Districts 7 & 8 PAC Meeting

Case 19987:

Proposal for a Development Agreement allowing a multi-unit residential development of 8 and 10 storeys at 1034-1056 Wellington Street, Halifax.

May 2nd, 2016

Design Revisions

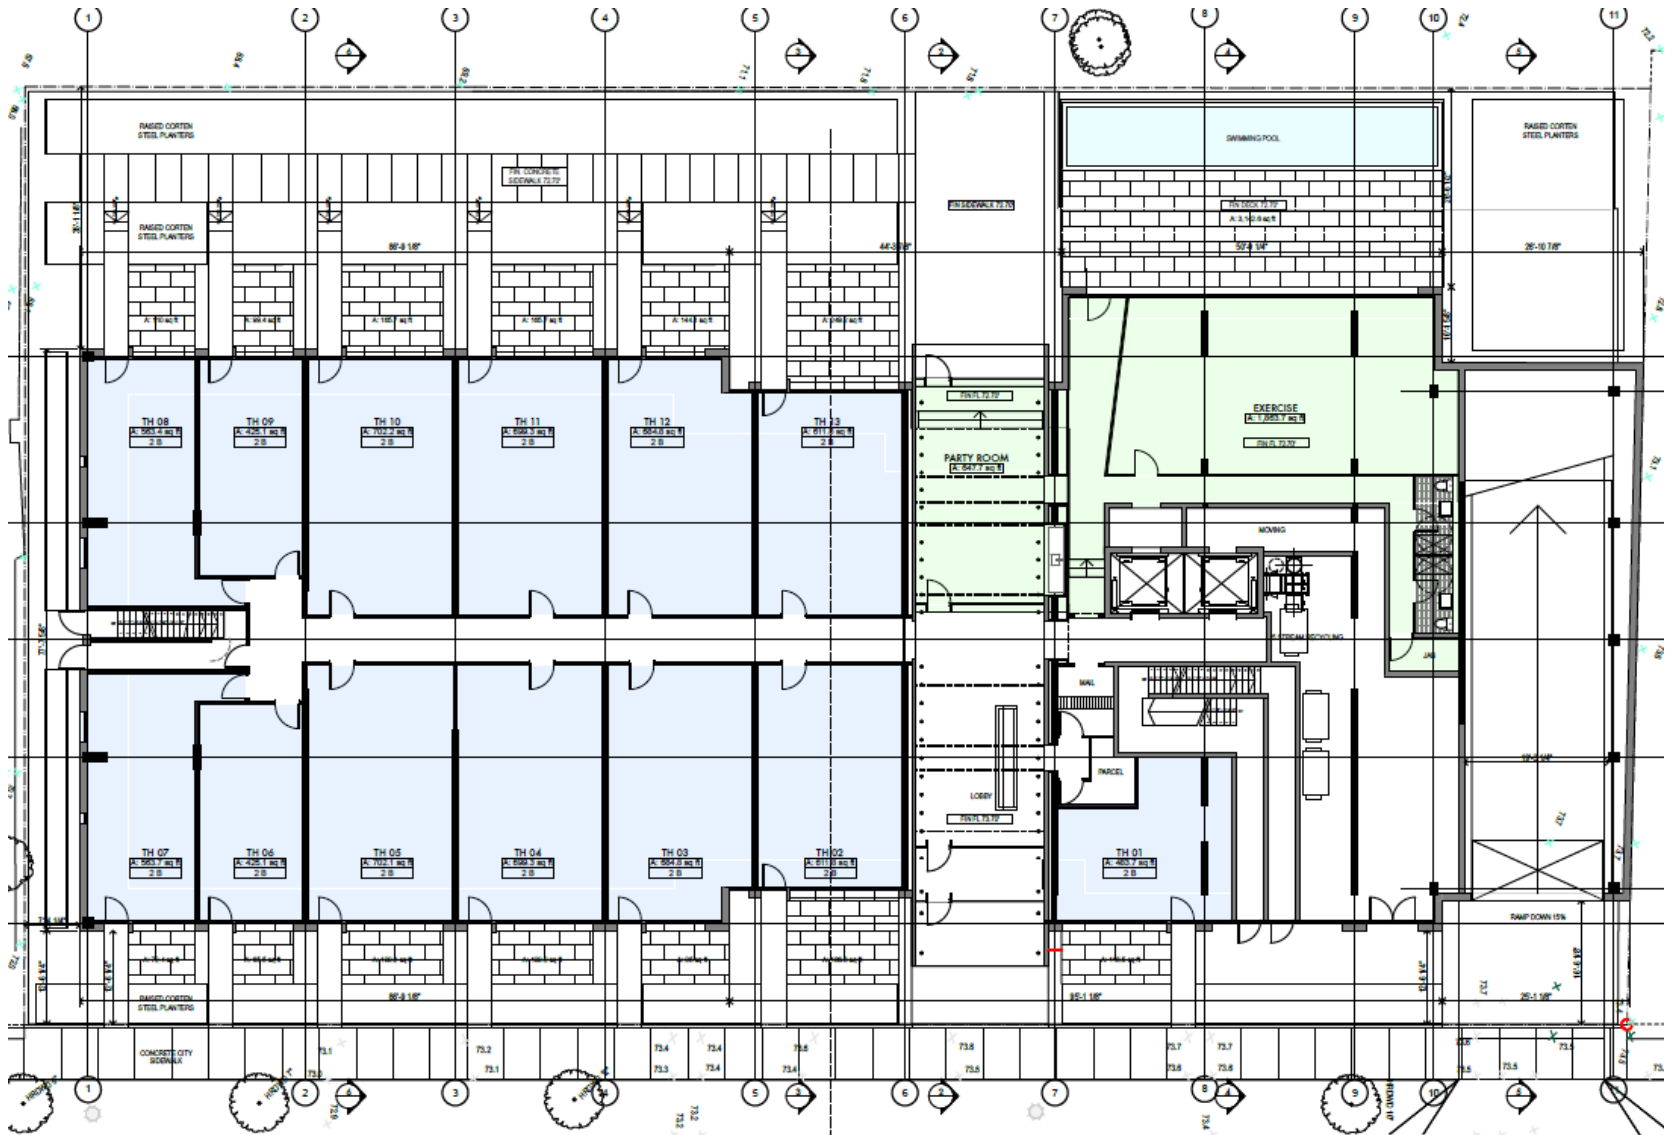
- Retained one tower design and reduction of parking levels from previous revisions.
- Setbacks changed to 7.76m to 9.95m (10.6m) on the rear, 2.98m (3.49m) along Wellington Street, 0.21m to 0.37m (2.02m) to the south and 0.12m to 0.46m facing north.
- Design proposed for interim south facing wall if phasing occurs.
- Ground floor townhouse units include two storeys with individual ground level access.
- Rooftop access and use for top floor units only on south and for mechanical space with screening on north.
- Exterior design and material change.
